Memorandum

To	North Dakota Public Service Commission	Pages	3
Subject	Case Number PU-18-280 Emmons-Logan Wind Energy Center Modifications of Energy Conversion Facility and Site Plan		
From	Emmons-Logan Wind, LLC		
Date	March 17, 2019

**Primary and Alternative
Turbine Modifications to
Late-Filed Exhibit 2**

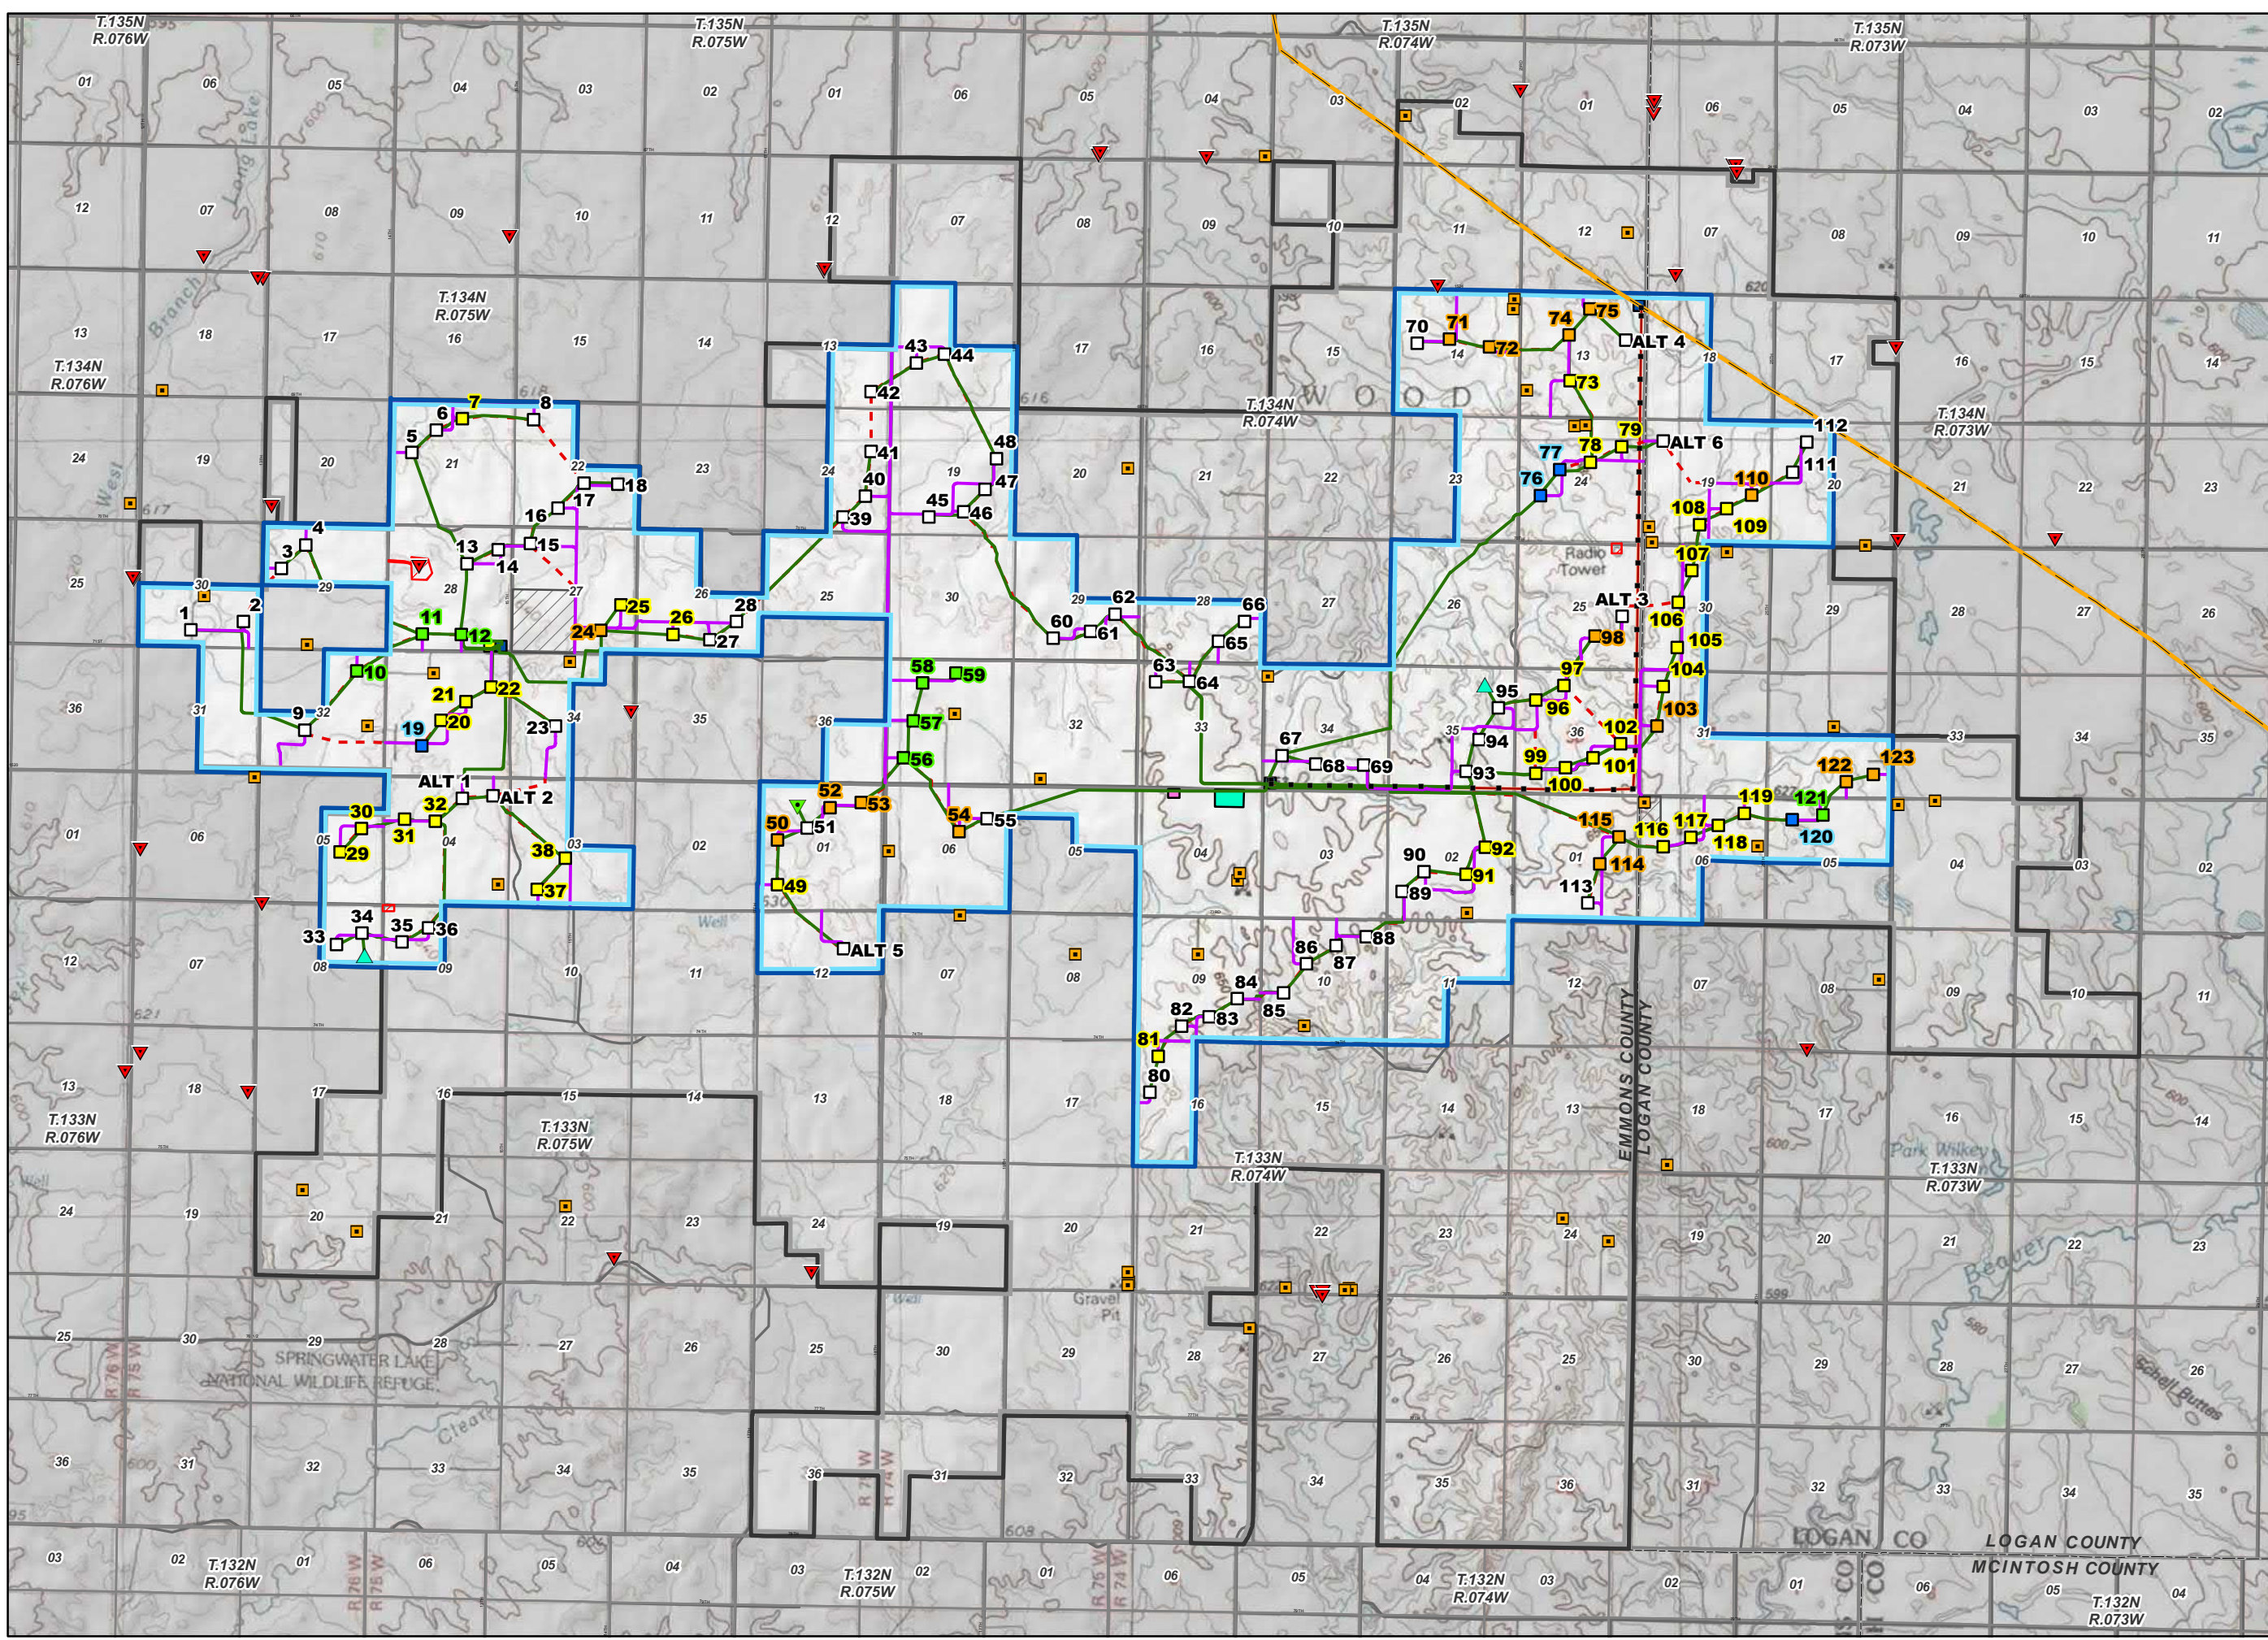
Emmons-Logan Wind was expecting to use 111 General Electric (GE) 2.5 megawatt (MW) and 12 GE 1.715 MW turbines. Emmons-Logan Wind is now proposing to use 35 GE 1.715 MW turbines and 88 GE 2.72 MW turbines at the previously permitted turbine locations (Attachments 2 and 3).

**Attachment 4
Sheet 1 of 6
Site Plan Modification
Map Book**

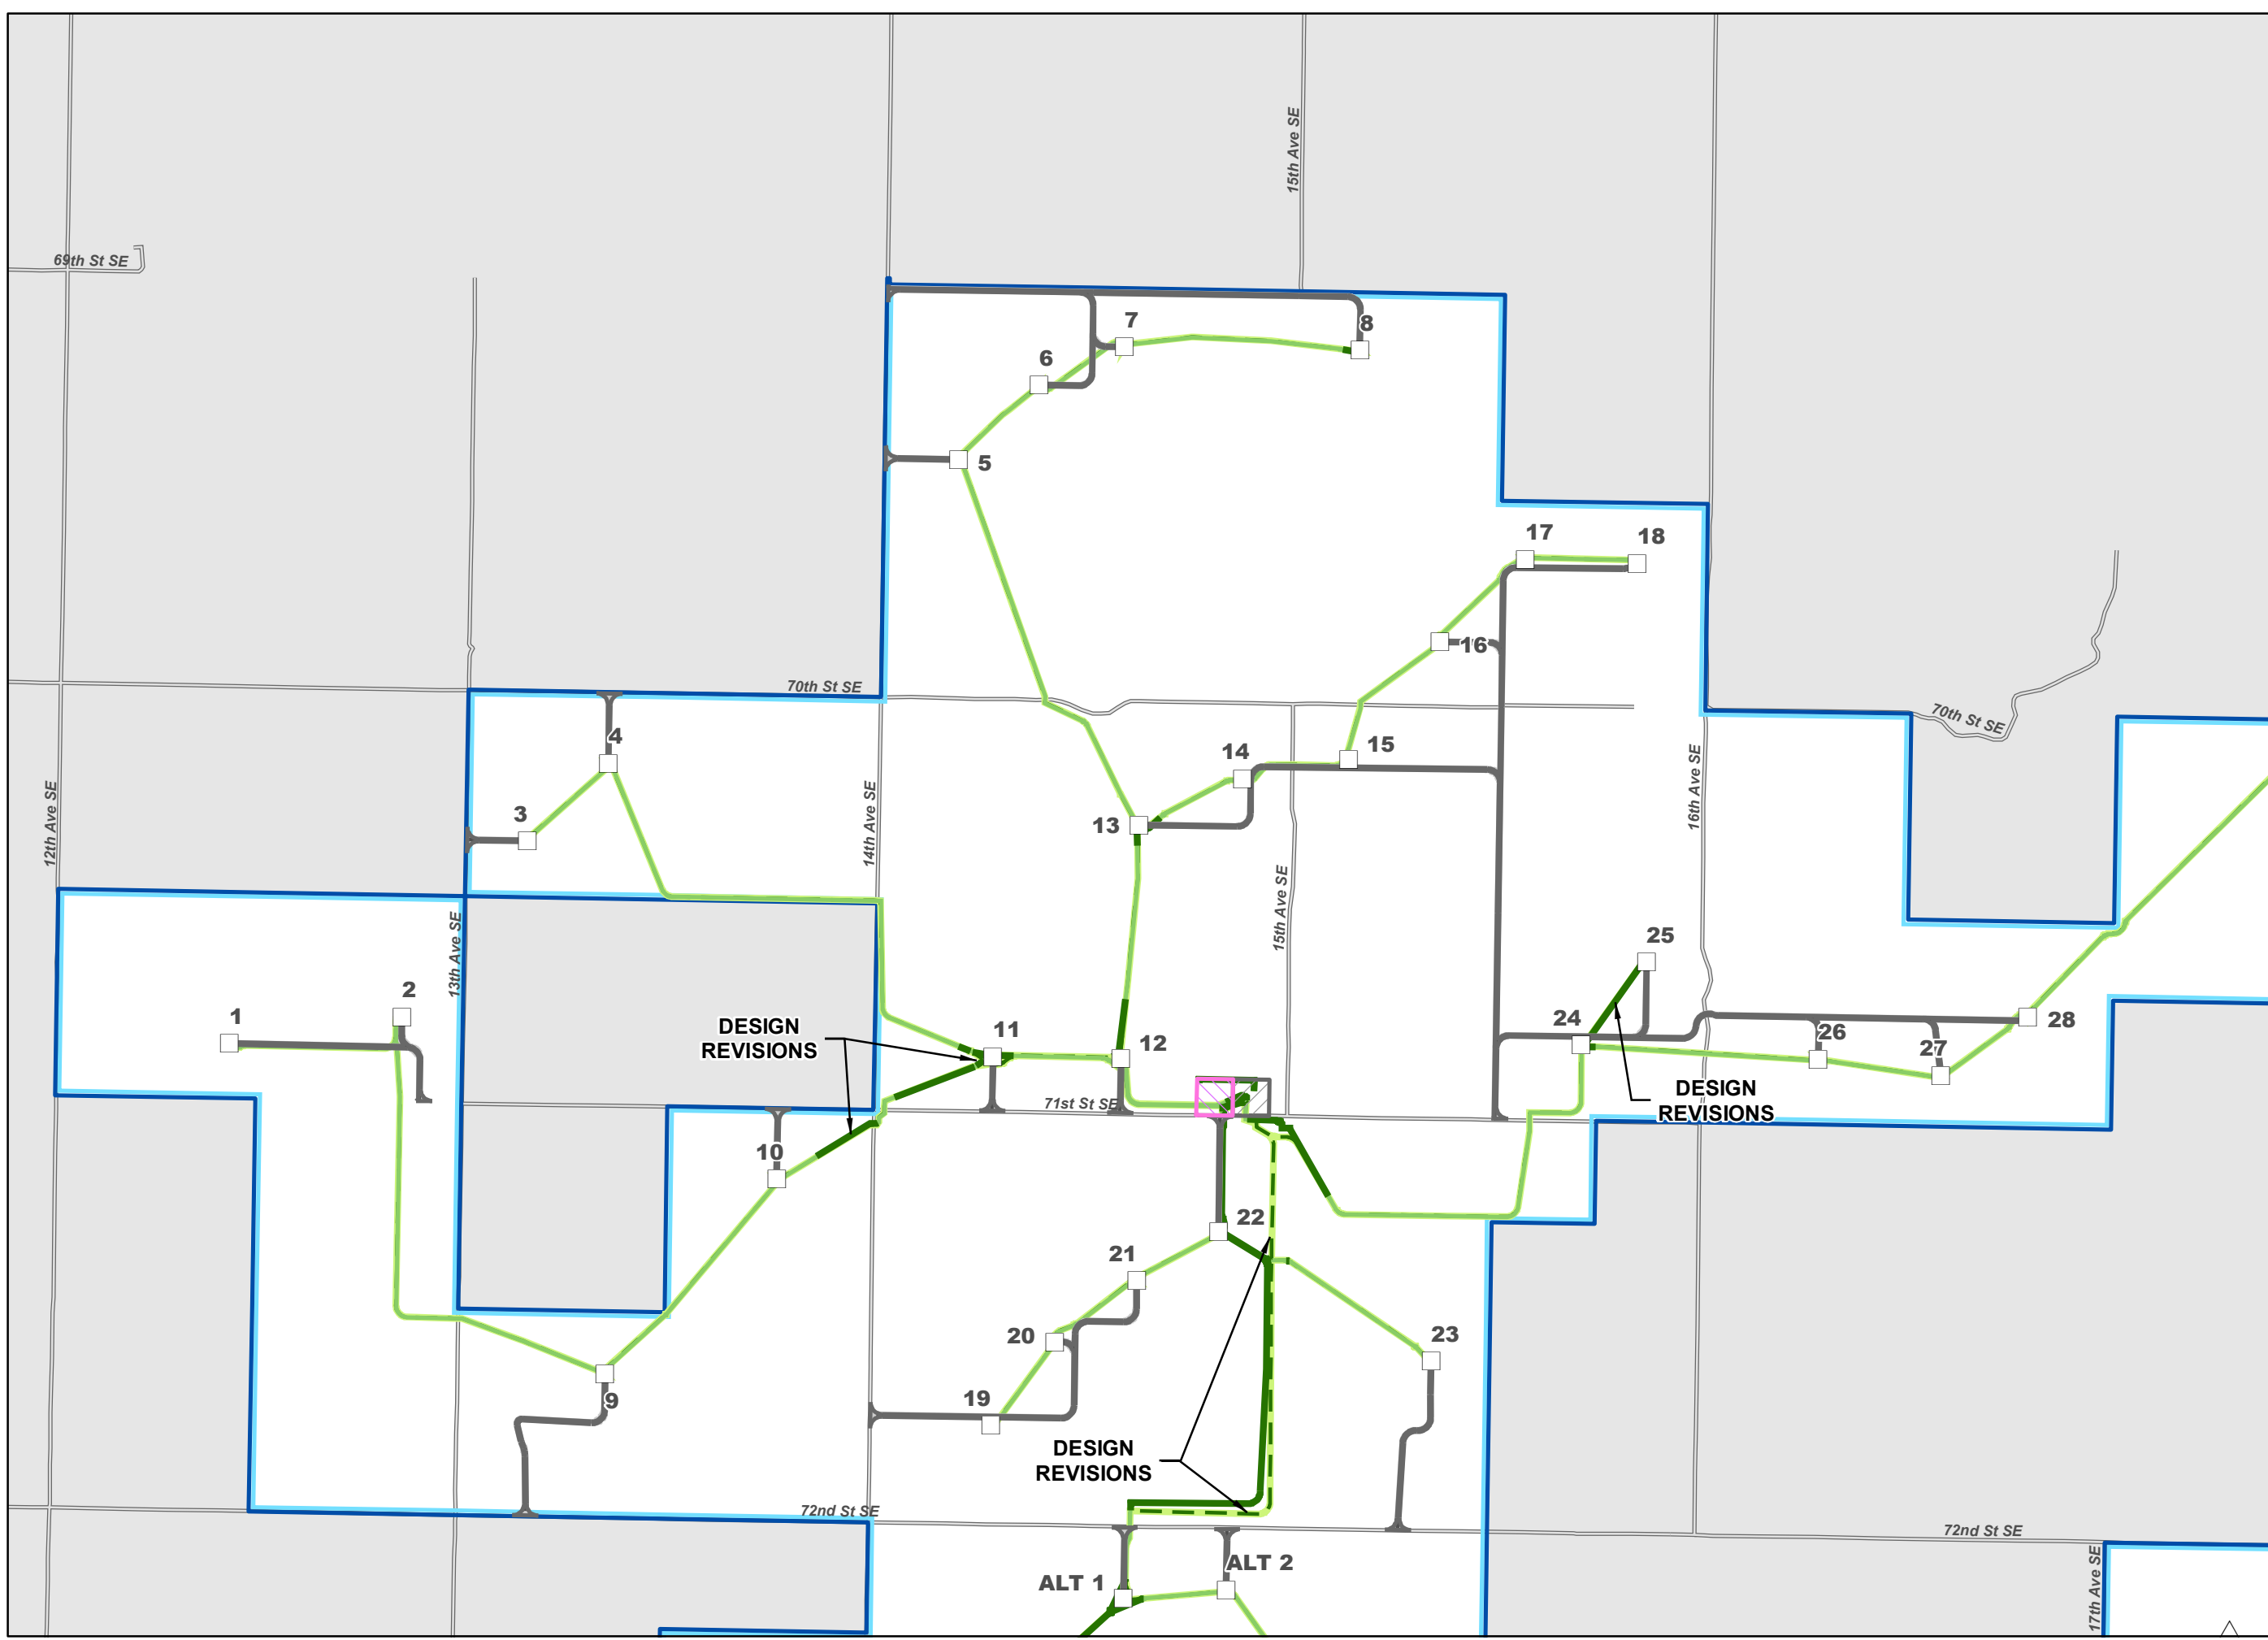
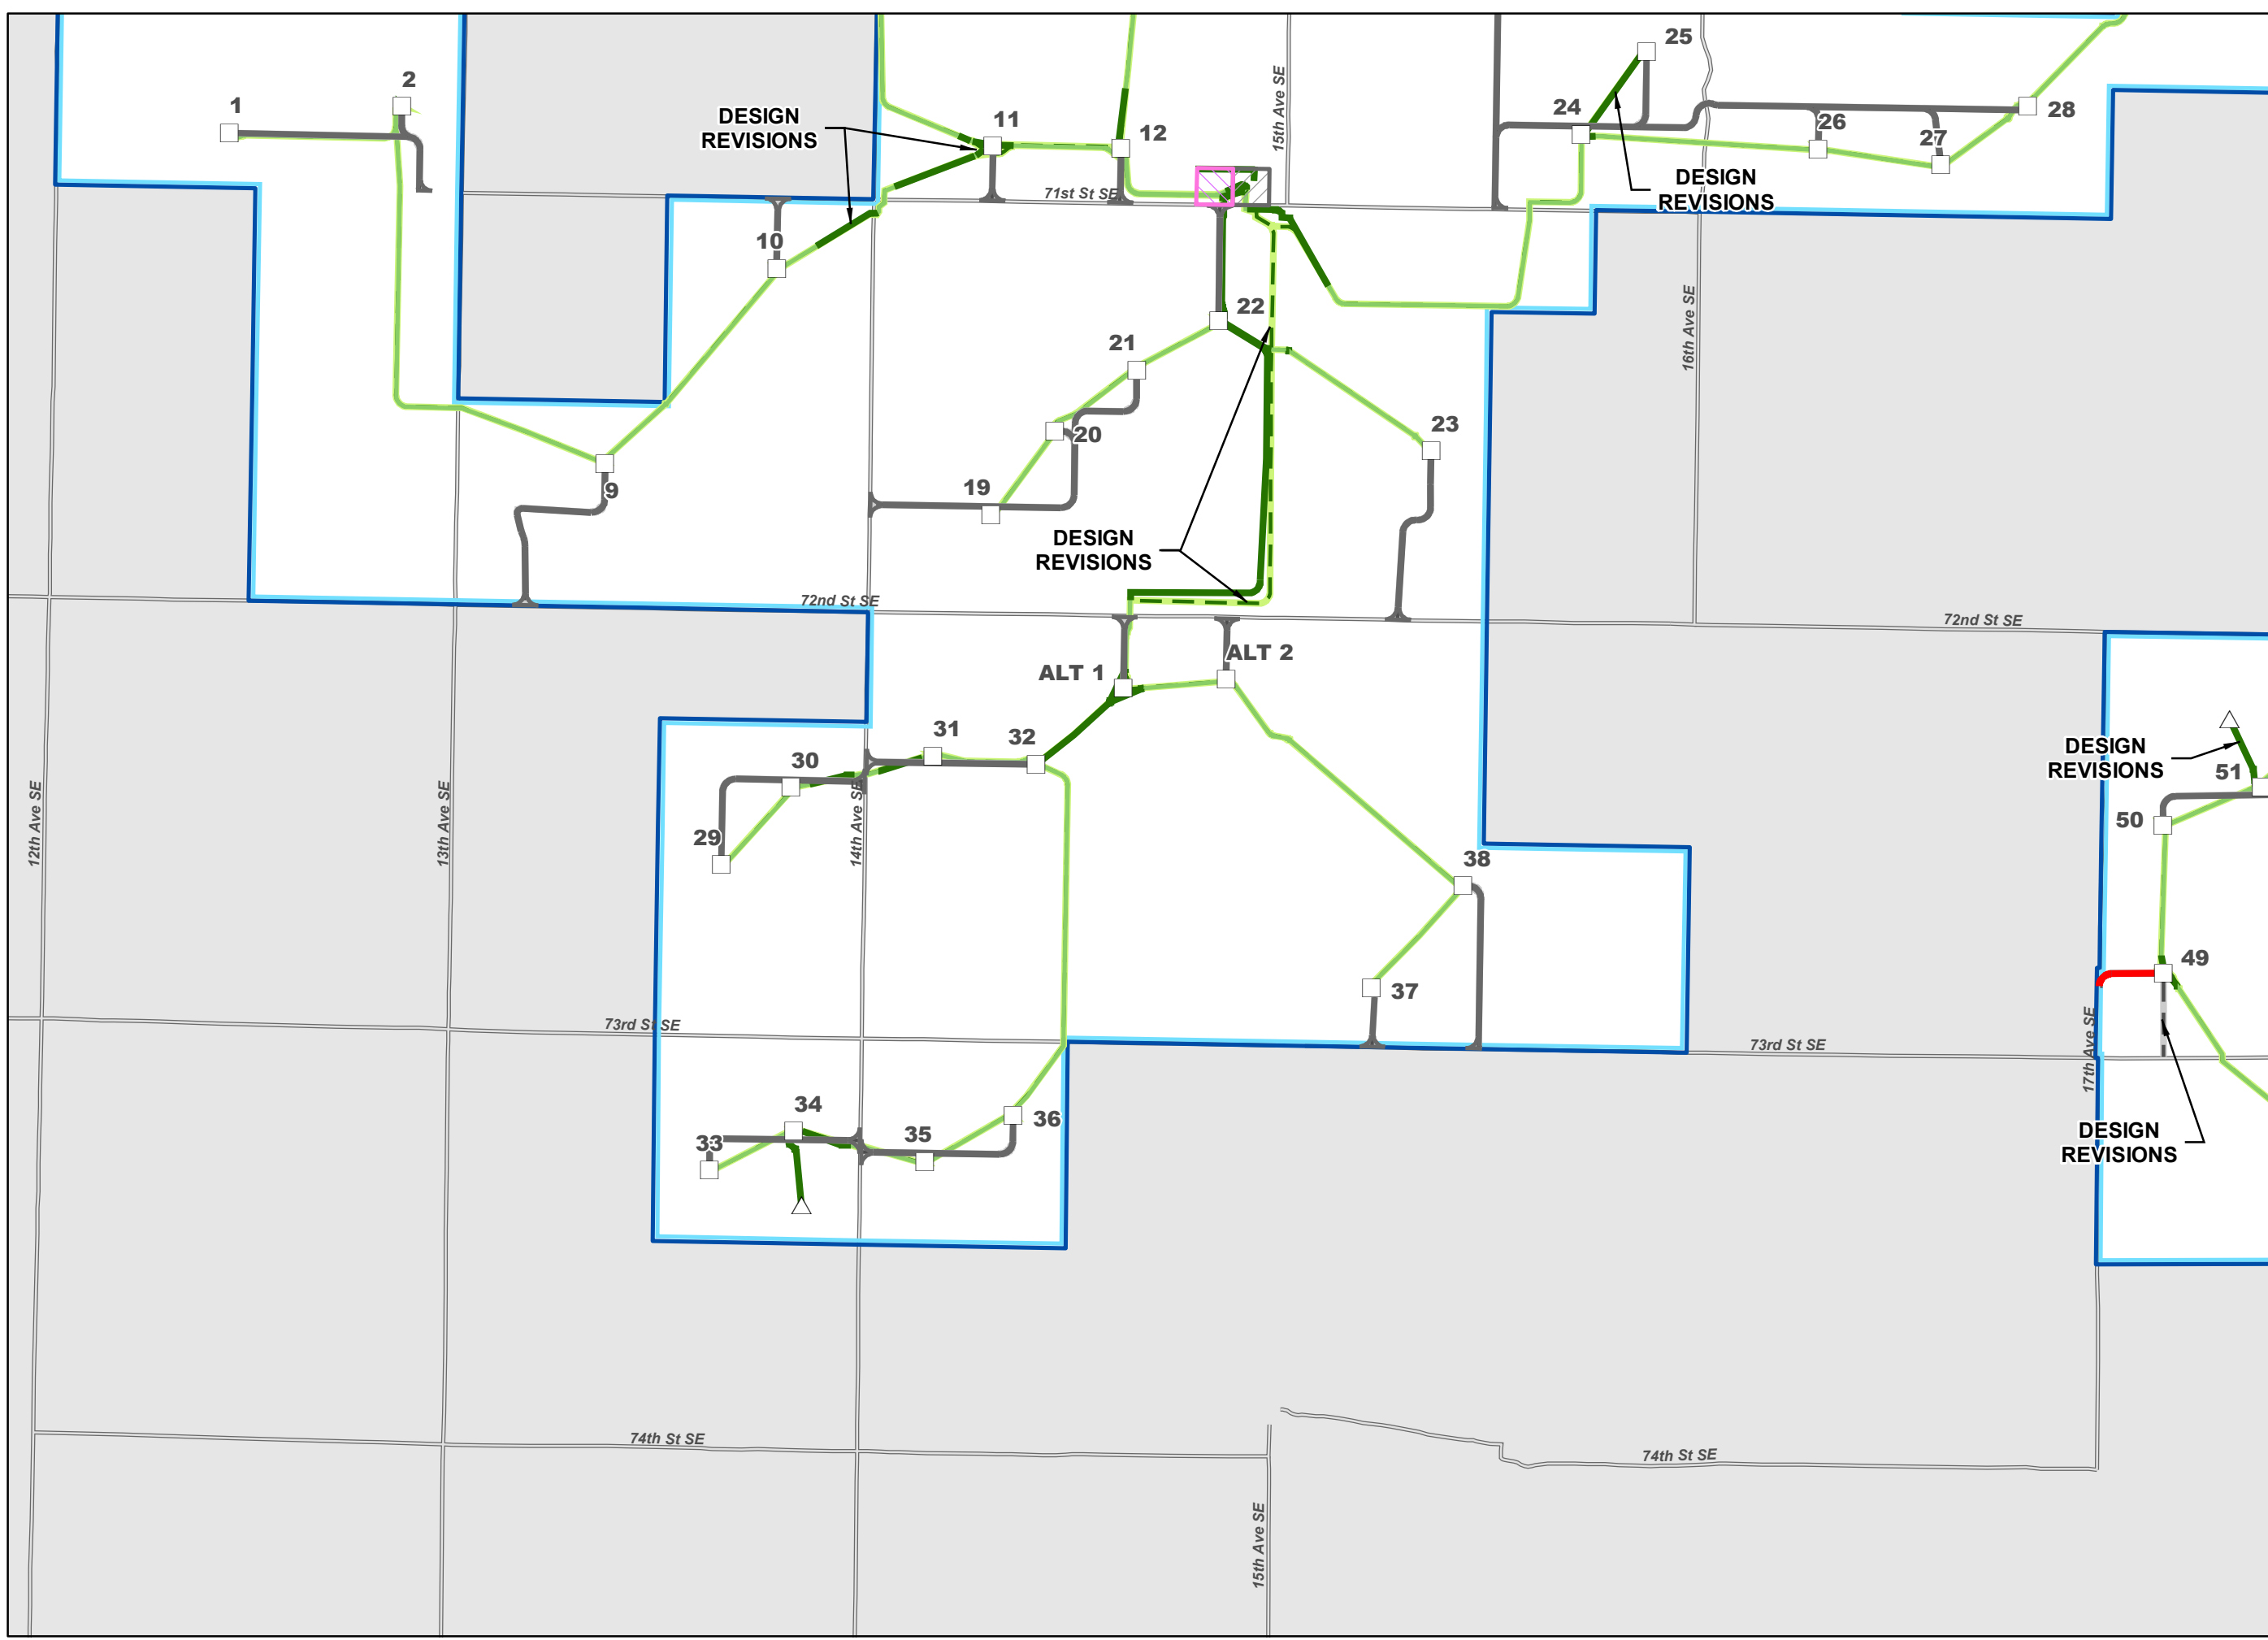
Emmons-Logan Wind proposes certain minor Project Site Plan modifications, including changes to certain collection lines and two access roads. Attachment 4 illustrates locations of the Site Plan modifications, whereas modifications that are imperceptible at the map scale can be viewed using the GIS shapefiles (Attachment 16). Most collection line changes are a result of the turbine model modification, but the collection lines between turbine 64 and the 230 kV substation and between turbine 69 and 93 are a result of landowner requests. This same landowner requested the access road change between turbine 69 and 93 as well. The access road to turbine 49 was also modified to accommodate preferred farming practices of the landowner. Although turbine locations have not changed, new numbers have been designated for most turbines due to the reassignment of proposed and alternative turbines (Attachment 3). The Project Site Plan modifications occur in areas previously surveyed for wetlands, cultural and tribal resources as described below. Attachments 2, 4, and 5 provide updated site plan maps.
